Access Compliance Report

Public Rights-of-Way

(Curb Ramps)

Intersection ID: 4686	Main Street: EVANSHIRE_DR	Cross Street: TRINITY_RD	Location: NW
ADA ID: 51F364D30C38	Ramp Type: BlendTrans1	Initial Pass/Fail: Fail	Overall Compliance: No
Severity Score: 8.75			
Codes/Mitigation Info/Possible Solution		Field Measurements/Component Compliance

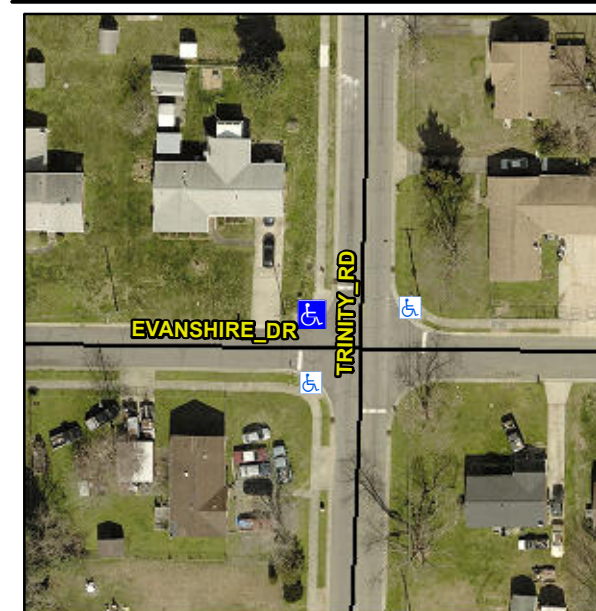
Compliance	Description	Data	Compliance	Description	Data
N/A	Ramp Length (in)	38.0	Yes	BlendTrans Slope (%)	3.1
No	Ramp Width (in)	37.0	Yes	BlendTrans XSlope (%)	2.0
N/A	Flare Type LT	N/A	N/A	Flare Type RT	N/A
N/A	Flare Slope LT (%)	N/A	N/A	Flare Slope RT (%)	N/A
N/A	Flare Traversable LT?	N/A	N/A	Flare Traversable RT?	N/A
N/A	Landing Length (in)	N/A	N/A	DWS Provided?	N/A
N/A	Landing Width (in)	N/A	N/A	DWS Contrast?	N/A
N/A	Landing Slope (%)	N/A	N/A	DWS Length (in)	N/A
N/A	Landing X Slope (%)	N/A	N/A	DWS Full Width?	N/A
N/A	Landing Curb? (Y/N)	N/A	N/A	DWS Offset (in)	N/A
N/A	Shared Landing?	N/A			
N/A	Gutter Ponding?	N/A	N/A	Gutter Slope (%)	N/A
N/A	Gutter Lip Ht (in)	1.0	N/A	Gutter X Slope (%)	N/A
N/A	Painted X Walk1?	No	N/A	Painted X Walk2?	No
	X Walk 1 Direction	To S		X Walk 2 Direction	To E
	X Walk 1 Width (in)	N/A		X Walk 2 Width (in)	N/A
	X Walk 1 Slope (%)	3.1		X Walk 2 Slope (%)	3.4
	X Walk 1 X Slope (%)	2.8		X Walk 2 X Slope (%)	0.3

Remove & Replace Curb Ramp With Two New Directional Ramps or Equivalent.

R304.5.1
